FIRST AVENUE PROPERTIES REZONING

Technical Memorandum

CEQR No.: 06DCP039M

January 25, 2008

Curb Heights on 700 First Avenue
Parcel with Proposed Modifications
Figure 9

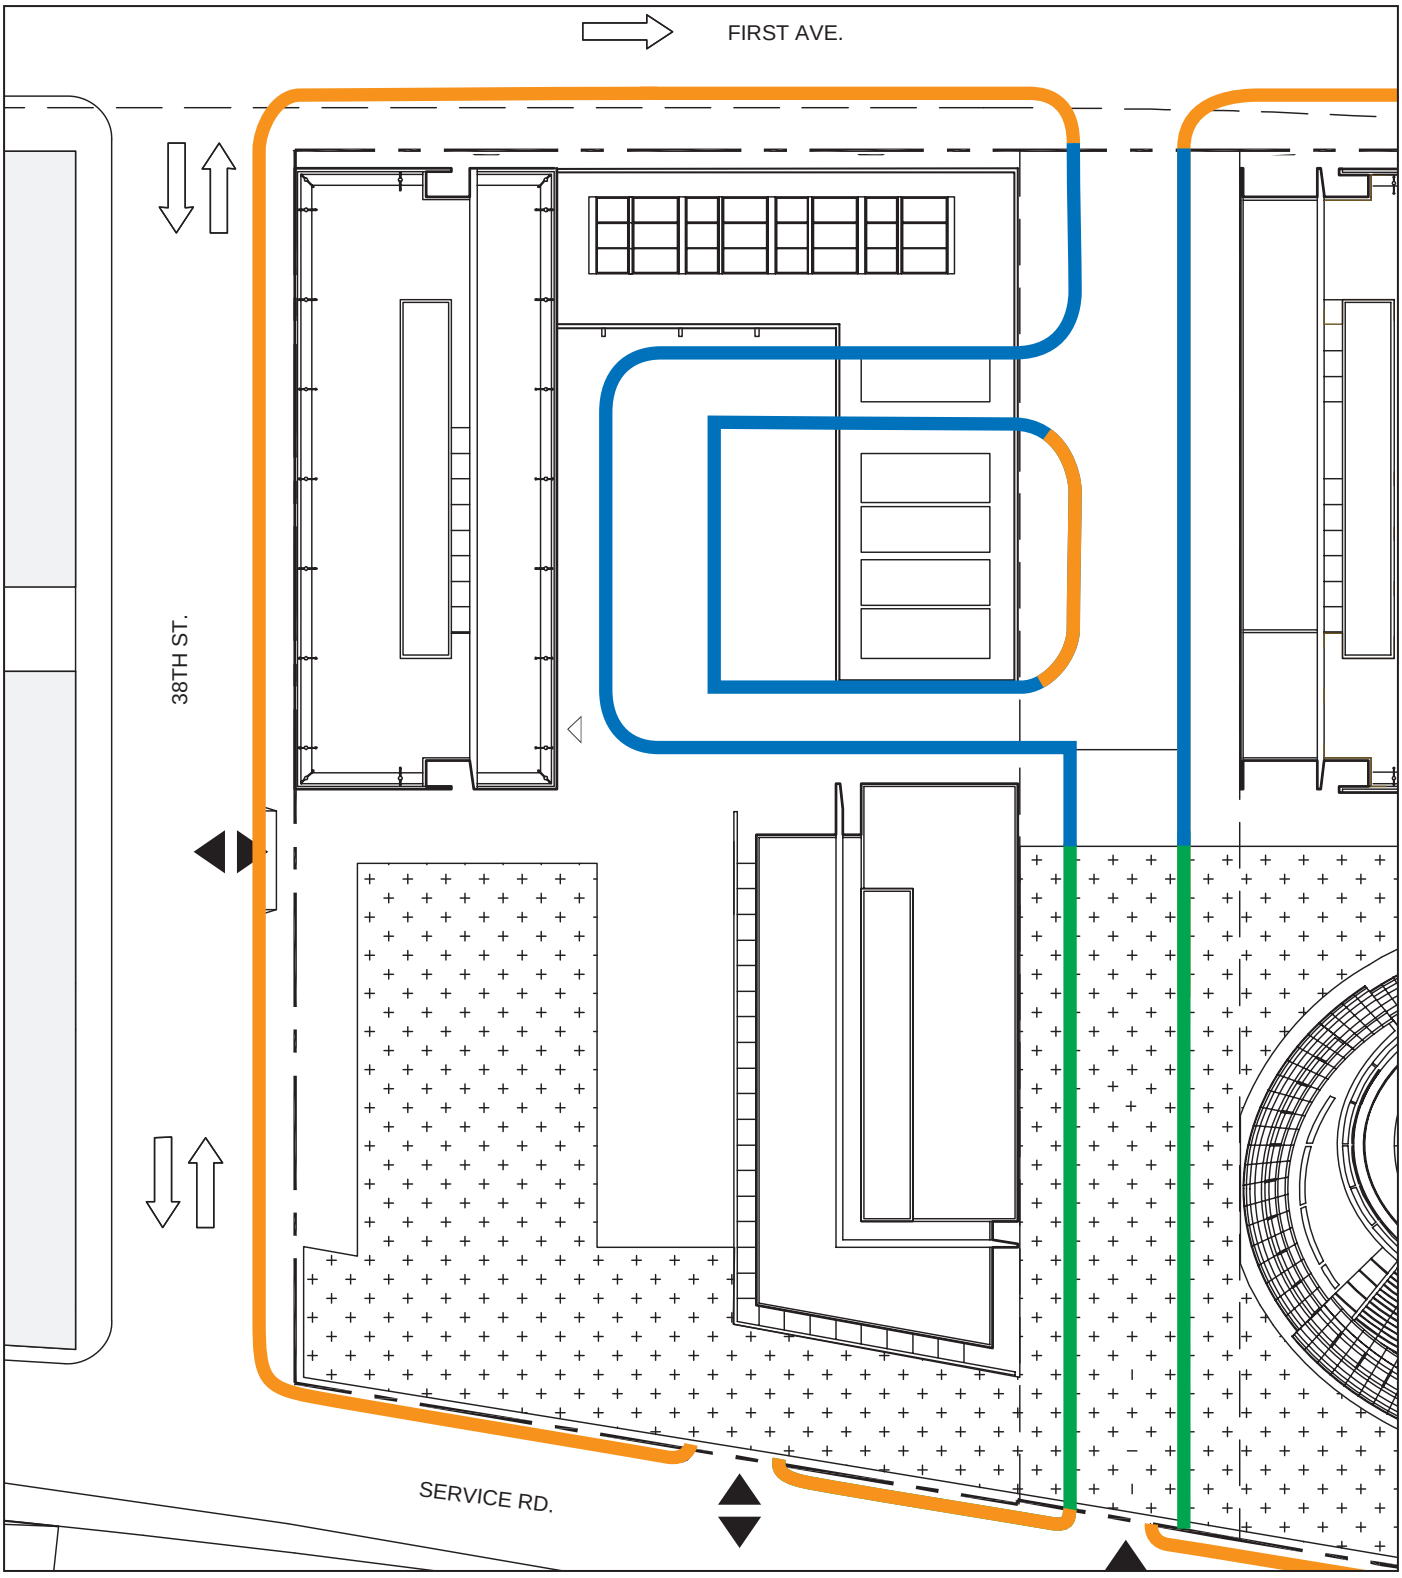
- The proposed modifications would raise curb heights within the plaza/open space area along the extension of East 39th Street on the 700 First Avenue parcel from 5 to 6 inches, as shown on Figure 9. In addition, street trees would be required to be 25 feet apart, rather than the 28 feet as considered in the FSEIS.

Modified School Construction Schedule
Figure 10

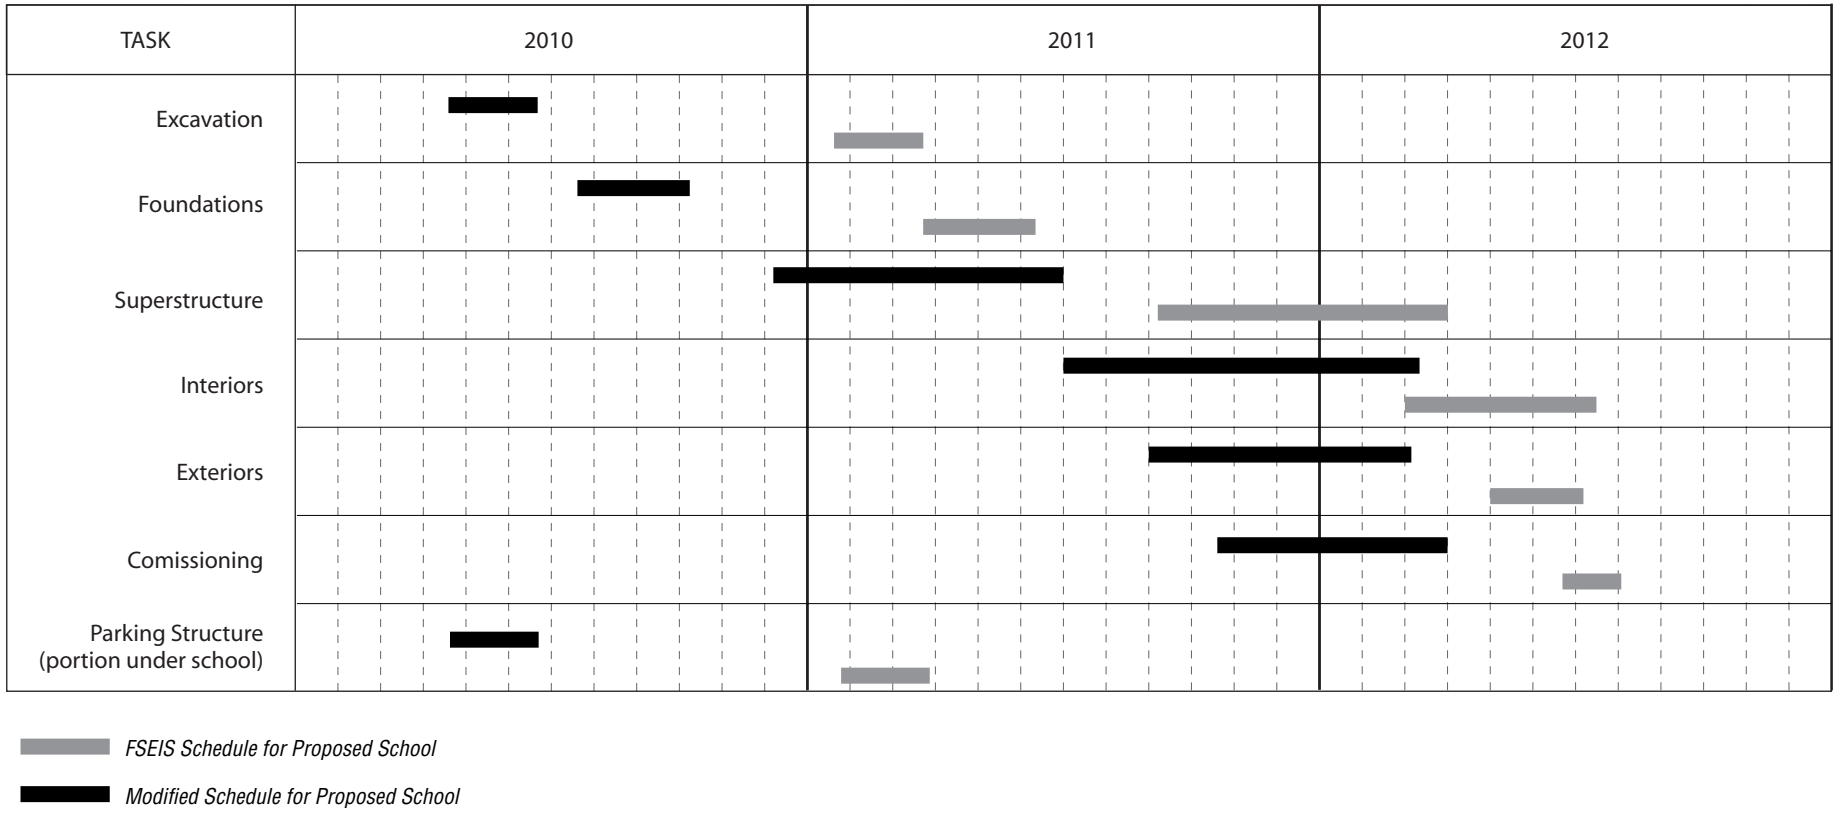
- The two construction scenarios for the Proposed Actions considered in the FSEIS assume that construction of the proposed school would begin in January 2011, so that the school could be operational by September 2012. After further and more detailed discussions with the School Construction Authority (SCA), it has become clear that the length of time required to build and program a new school is longer than anticipated in the FSEIS schedule. Therefore, this Technical Memorandum addresses a revised construction schedule, with work on the school beginning nine months earlier, in April 2010, as shown on Figure 10. The opening date of September 2012 would be unchanged.
